Change of the External Appearance of FX5U CPU Modules and Powered I/O Modules

March 2026

3 DETAILS ON THE CHANGES

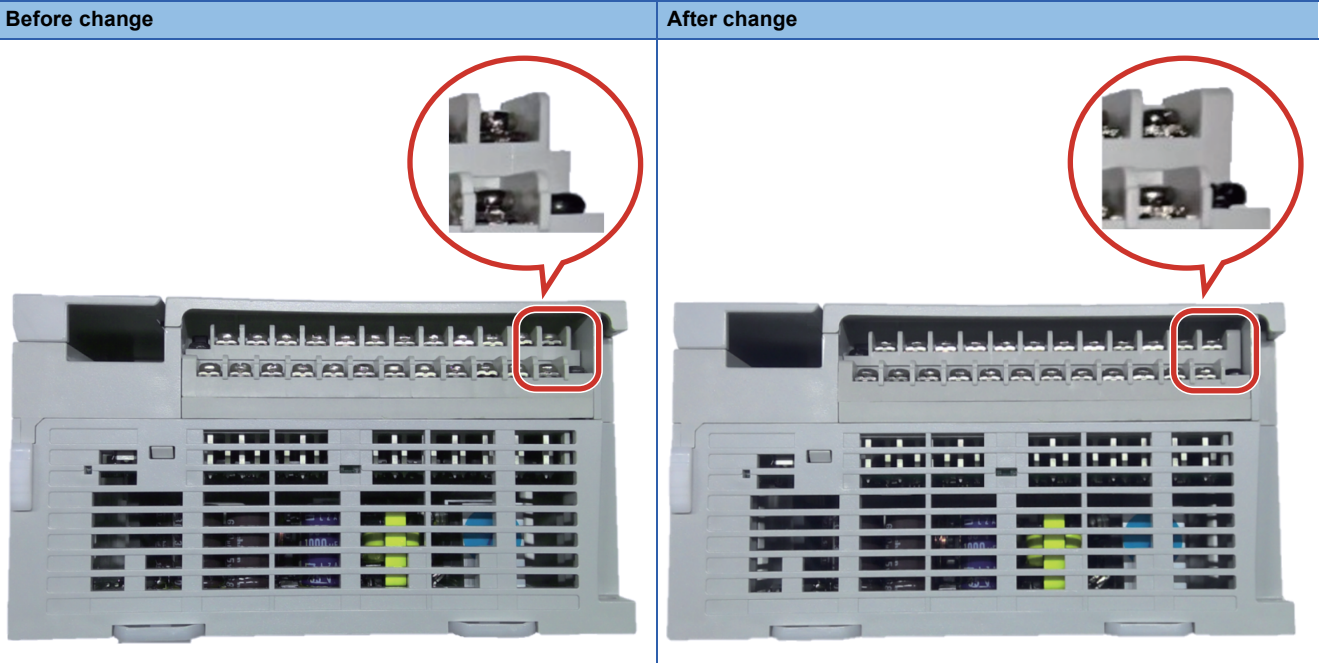
The external appearance of terminal block will be changed as shown below.
